Access Compliance Report

Public Rights-of-Way

Intersection ID: 50541	Main Street: CAYENNE_DR	Cross Street: LEMONGRASS_LN	Location: NW
ADA ID: 48FC061802B3	Ramp Type: PerpDiag	Initial Pass/Fail: Fail	Overall Compliance: No
Severity Score: 21.25			
Codes/Mitigation Info/Possible Solution		Field Measurements/Component Compliance

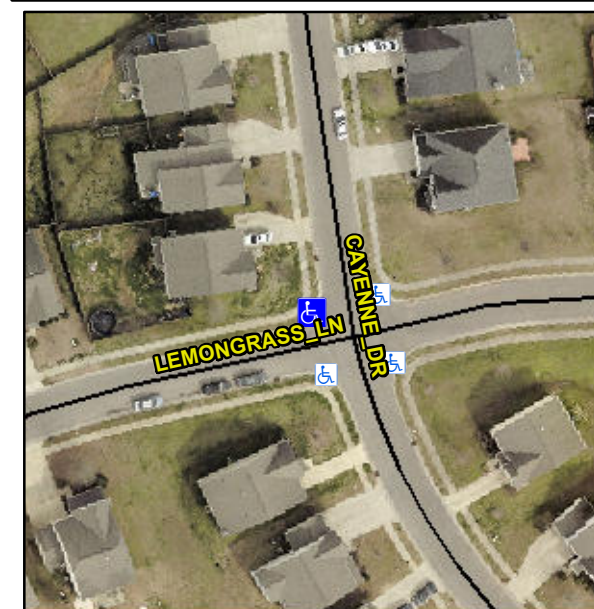
Not Found, R304.5.1, R304.2.2

Compliance	Description	Data	Compliance	Description	Data
N/A	Ramp Length (in)	48.0	No	Ramp Slope (%)	9.0
No	Ramp Width (in)	43.0	Yes	Ramp XSlope (%)	1.1
N/A	Flare Type LT	N/A	N/A	Flare Type RT	N/A
N/A	Flare Slope LT (%)	N/A	N/A	Flare Slope RT (%)	N/A
N/A	Flare Traversable LT?	N/A	N/A	Flare Traversable RT?	N/A
N/A	Landing Length (in)	N/A	N/A	DWS Provided?	N/A
N/A	Landing Width (in)	N/A	N/A	DWS Contrast?	N/A
N/A	Landing Slope (%)	N/A	N/A	DWS Length (in)	N/A
N/A	Landing X Slope (%)	N/A	N/A	DWS Full Width?	N/A
N/A	Landing Curb? (Y/N)	N/A	N/A	DWS Offset (in)	N/A
N/A	Shared Landing?	N/A			
N/A	Gutter Ponding?	N/A	N/A	Gutter Slope (%)	N/A
N/A	Gutter Lip Ht (in)	N/A	N/A	Gutter X Slope (%)	N/A
N/A	Painted X Walk1?	No	N/A	Painted X Walk2?	No
	X Walk 1 Direction	To S		X Walk 2 Direction	To E
N/A	X Walk 1 Width (in)	N/A	N/A	X Walk 2 Width (in)	N/A
	X Walk 1 Slope (%)	4.1		X Walk 2 Slope (%)	2.0
	X Walk 1 X Slope (%)	0.3		X Walk 2 X Slope (%)	4.5

Remove & Replace Curb Ramp With Two New Directional Ramps or Equivalent.
